May 31, 2020

Subject: SMART Public Comment re: 225 CMR 20.00 and Guidelines Regarding Land Use, Siting, and Project Segmentation

Figure 2. Extensive swaths of bedrock (granite per MassGIS Oliver), shown here in red, underlie the Connecticut River Valley, Worcester Corridor and the Eastern Shore—about 50% of the state.

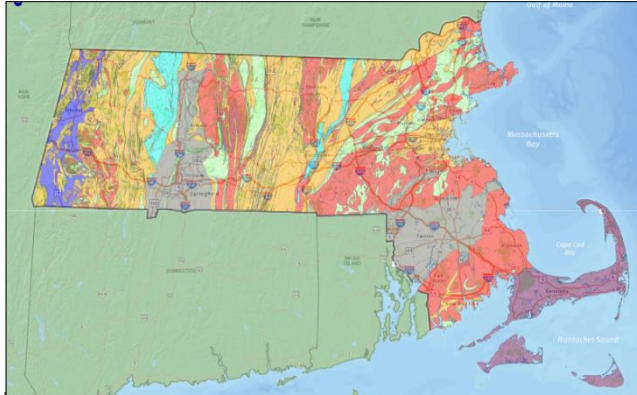
4. 225 CMR 20.05(5)(e)6d. As shown in Figure (2) above, about half of Massachusetts is underlain by bedrock, and much of that is outcroppings or near surficial. For example, in a recent soil survey for the proposed solar array at Gulf Road in Belchertown developed by Blue Wave Solar, 50% of the soil test pits showed bedrock at less than 9 feet from the surface.⁵ Of these, 75% found bedrock at less than 5 feet. Groundwater was also a problem. Groundwater was found in 56% of the pits, and in all but one at a depth of less than 4 feet.

- a. The use of “screw-type, or post driven pilings,” as suggested by the statute, would be impractical, leaving only concrete ballasts or hammer drilling in the bedrock substrate as options. Based on the prohibitive cost of thousands of ballasts for a commercial array, the developer would choose to hammer drill the posts into the granite and concrete grout the holes. This is a problem. To decommission the facility and remove the array, the only option would be to cut the steel posts below grade, in turn producing large quantities of iron oxide (rust) that would infiltrate aquifers throughout central Massachusetts. Small amounts of rust are toxic to fish and reptiles, iron poisoning is debilitating to people, and rusty water would be objectionable.
